NIAGARA MOHAWK POWER CORPORATION

LICENSE NO. NPF-69

DOCKET NO. 50-410

Proposed Changes to Technical Specifications

FIGURE 3.4.1.1-1 PERCENT OF RATED CORE THERMAL POWER VS. PERCENT OF RATED CORE FLOW

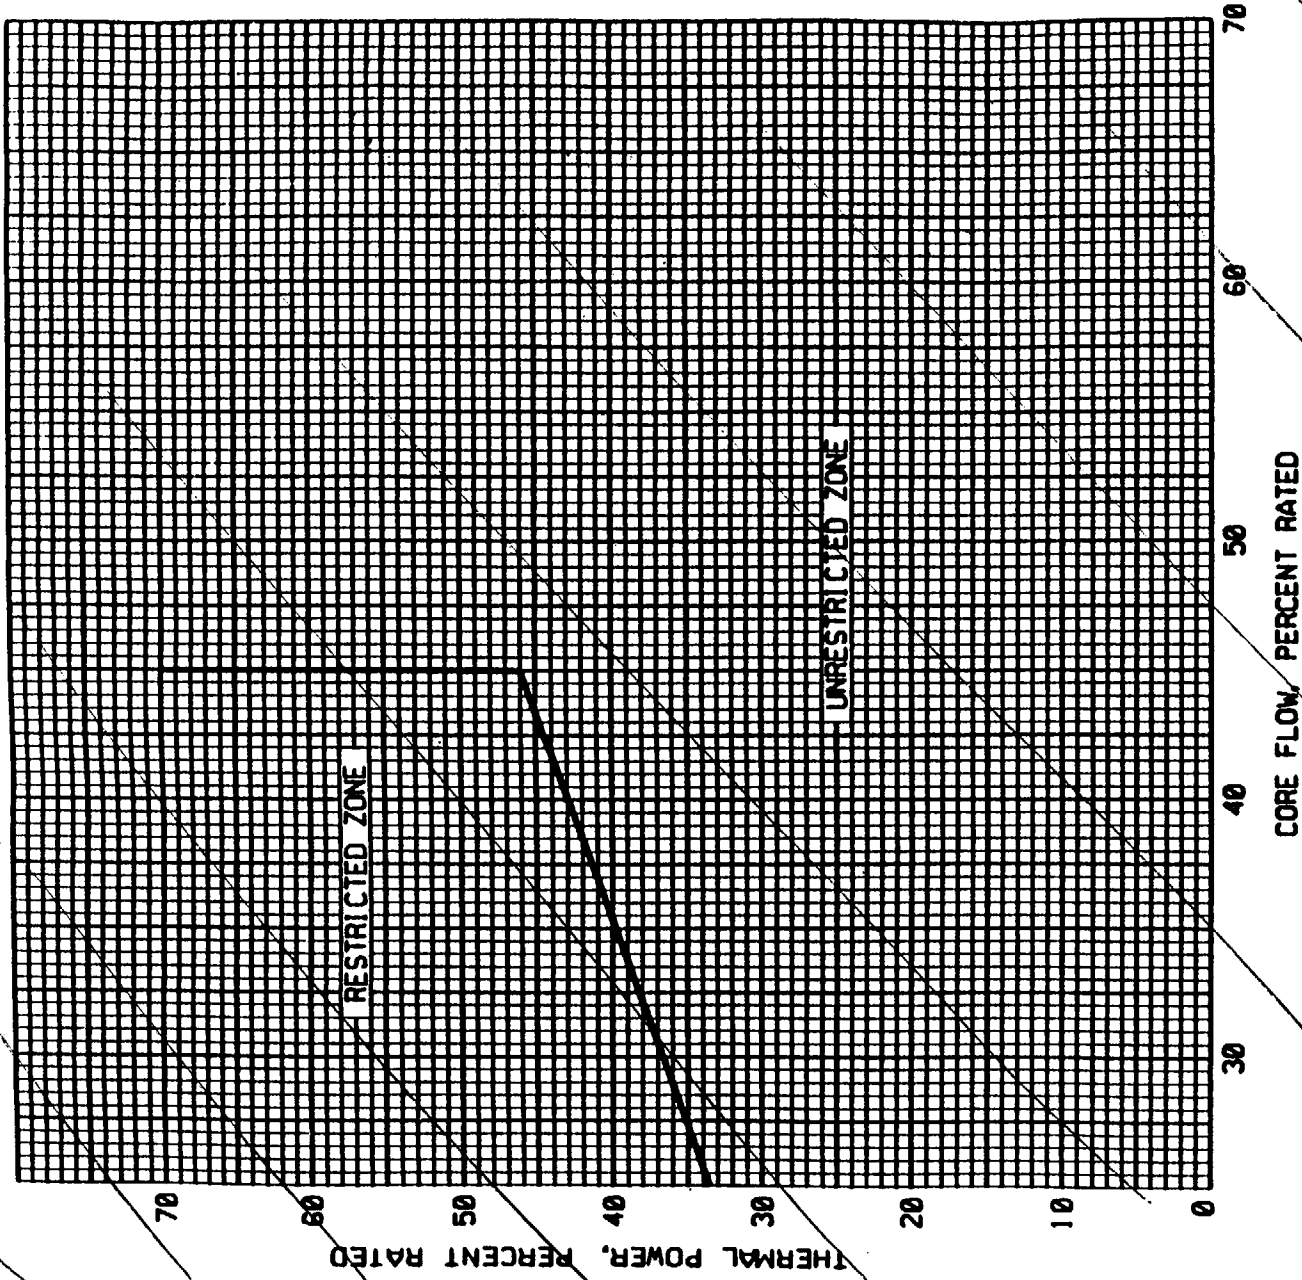
FIGURE 3.4.1.1-1 HAS BEEN DELETED

Based on the above discussion, deletion of the stability related operational restrictions and associated Bases is acceptable, and is consistent with and supported by implementation of the OPRM Upscale trip function. NMPC also proposes to delete the words "initiate measures to" from TS 3.4.1, Action b. This will eliminate confusion as to whether the TS requirement is to "initiate measures" in 6 hours or be in startup within 6 hours. These changes are not within the scope of NEDC-32410P-A, Supplement 1.

- a. ~~Total core flow greater than or equal to 45% of rated core flow, or~~
- b. ~~THERMAL POWER within the unrestricted zone of Figure 3.4.1.1-1.~~

- c. With one or two reactor coolant system recirculation loops in operation and total core flow less than 45% but greater than 39%** of rated core flow and THERMAL POWER within the restricted zone of Figure 3.4.1.1-1:

- d. With one or two reactor coolant system recirculation loops in operation and total core flow $\leq 39\%$ ** and THERMAL POWER within the restricted zone of Figure 3.4.1.1-1, within 15 minutes initiate corrective action to reduce THERMAL POWER to within the unrestricted zone of Figure 3.4.1.1-1 or increase core flow to $> 39\%$ ** within 4 hours.
